RENESAS TECHNICAL UPDATE

| Product Category | MPU&MCU | Document No. | TN-H8*-263A/EA | Rev. | 1.0 |
| Title | Correction of Errors Concerning the IrDA Function of the SCI in the H8S/2168 Group and H8S/2158 | | Information Category | Correction or Supplement of Documents | |
| Applicable Product | H8S/2168, H8S/2167, H8S/2166, and H8S/2158 | Lot No. | Reference Document | H8S/2168 Group Hardware Manual | |

Correction 2: Figure 14.36, IrDA Block Diagram, in the H8S/2168 Group Hardware Manual

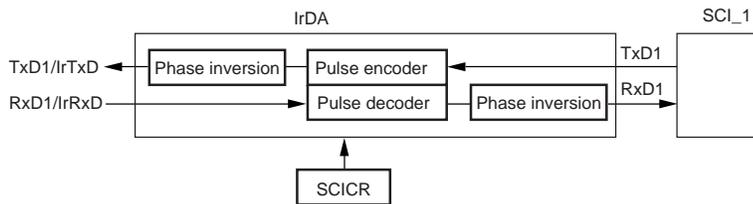
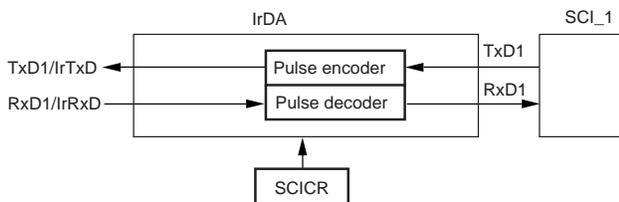
The descriptions of the phase inversion function of the IrDA in the serial communication interface (SCI, IrDA, and CRC) are deleted.
